[Docket No. FAA-2024-0769; Project Identifier AD-2023-00556-T; Amendment 39-22815; AD 2024-16-09]

Airworthiness Directives; The Boeing Company Airplanes

Final rule.

Figure 1 to Paragraph (h)(3)—Cap Sealing Dimensions (all Dimensions are in Inches)

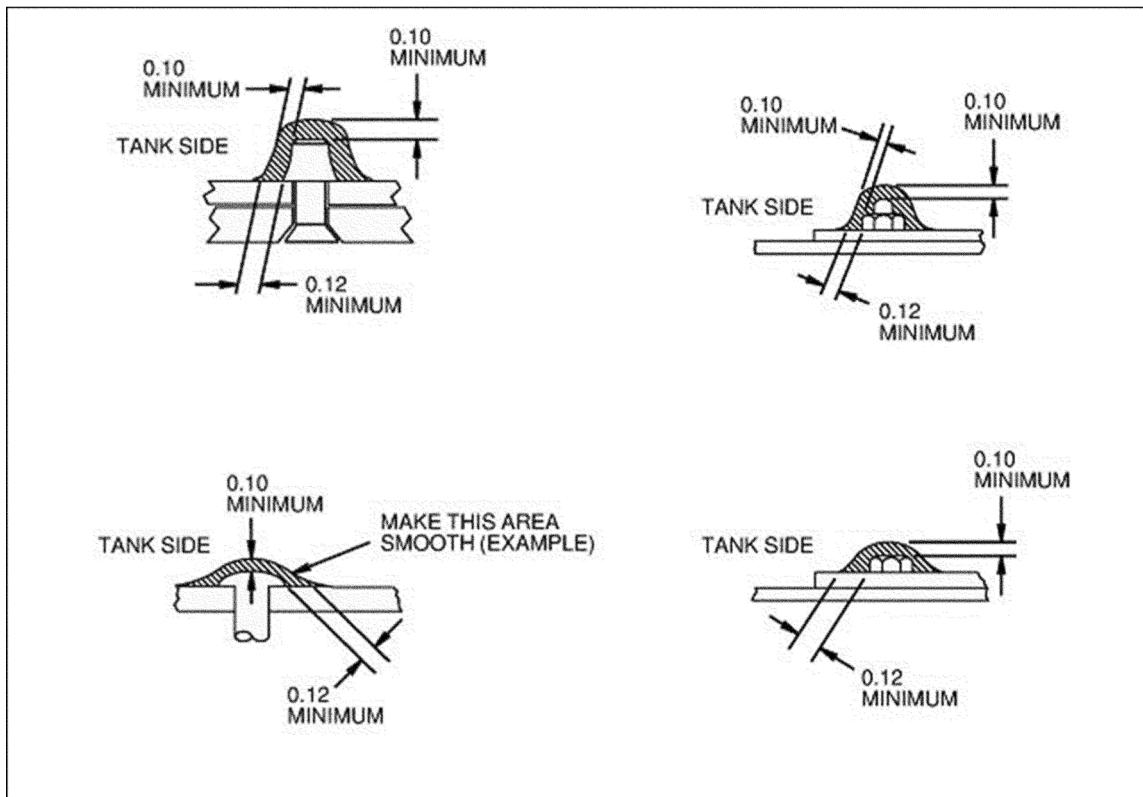
Boeing requested that paragraph (h)(3) of the proposed AD be clarified to specify that only the fuel tank side of fastener locations that penetrate the fuel tank boundary require cap seal dimensions to

meet the dimensions given in Figure 1 to paragraph (h)(3) of the proposed AD. Boeing stated that the service information referenced in Boeing Alert Requirements Bulletin 777-53A0100 RB, dated March 16, 2023, contain instructions for applying cap seals to fasteners that penetrate a fuel tank boundary and fasteners that do not penetrate a fuel tank boundary. Boeing added that for fasteners that do not penetrate a fuel tank boundary, fastener sealing is used as a pressure seal to help mitigate corrosion and have sealing specifications that include minimum thickness requirements less than the amount shown in paragraph (h)(3) of the proposed AD that are acceptable for their intended function outside of the fuel tank. Boeing stated that for fasteners that penetrate the fuel tank, the cap seals on the interior side of the fuel tank act as a primary fuel seal, providing fault tolerance against electromagnetic effects (electrical fault currents and lightning currents), and are also cap sealed on the exterior side for corrosion prevention.

Boeing concluded that only the cap seals on the interior side of the fuel tank require the dimensions specified in Figure 1 of paragraph (h)(3) of the proposed AD to perform their intended function, which is consistent with the labels shown in Figure 1 of paragraph (h)(3) of the proposed AD. Boeing recommended replacing the text “applying a cap seal (sealant) to a fastener, fastener head, and fastener threads and collars, for this AD, during application of any cap seal to a fastener, fastener head, or fastener threads and collars” with the text “applying a cap seal (sealant) to a fastener location that penetrates the fuel tank boundary, for this AD, during application of any cap seal to a fastener, fastener head, or fastener threads and collars inside the fuel tank.”

Boeing requested that the FAA add a note to paragraph (h)(3) of the proposed AD to refer to Boeing Model 777 Aircraft Maintenance Manual (AMM) section 28-11-00 as an acceptable cap sealing

procedure to accomplish the actions required in that paragraph. Boeing stated it has received numerous queries from operators on Figure 1 to paragraph (h)(4) of AD 2023-17-14, which is identical to Figure 1 to paragraph (h)(3) of the proposed AD. Operators have asked whether Boeing Model 777 AMM section 28-11-00 would be an acceptable procedure for accomplishing the requirements of paragraph (h)(4) of AD 2023-17-14. Boeing stated it believes that AMM 28-11-00 is an acceptable procedure for performing cap sealing inside the fuel tank because the AMM is the source material for the contents in Figure 1 to paragraph (h)(3) of the proposed AD and contains the same minimum seal thickness dimensions as shown in Figure 1.

The FAA agrees to clarify paragraph (h)(3) of this AD for the reasons provided by the commenter. Locations that do not penetrate the fuel tank boundary do not require the same sealant application procedures. The FAA has added the text “inside the fuel tank” to paragraph (h)(3) of this AD. However, the FAA did not replace the text “to a fastener, fastener head, and fastener threads and collars” with the text “to a fastener location that penetrates the fuel tank boundary,” as recommended by the commenter, because the text “to a fastener, fastener head, and fastener threads and collars inside the fuel tank” better aligns with the language within the service information.

The FAA agrees. Boeing 777 AMM 28-11-00 meets the sealant requirements of Figure 1 to paragraph (h)(3) of this AD. As such, it would be an acceptable procedure to follow when sealing inside the fuel tank in accordance with paragraph (h)(3) of this AD. The FAA has added a note to paragraph (h)(3) of this AD accordingly.

(3) Where any service information referenced in Boeing Alert Requirements Bulletin 777-53A0100 RB, dated March 16, 2023, specifies applying a cap seal (sealant) to a fastener, fastener head, and fastener threads and collars inside the fuel tank, for this AD, during application of any cap seal to a fastener, fastener head, or fastener threads and collars inside the fuel tank, the cap seal must be applied using a cap sealing procedure with thickness greater than or equal to the dimensions given in Figure 1 to paragraph (h)(3) of this AD.

Note 4 to paragraph (h)(3): Guidance on an acceptable cap sealing procedure for accomplishing the actions required by paragraph (h)(3) of this AD can be found in Boeing Model 777 Aircraft Maintenance Manual (AMM) section 28-11-00.
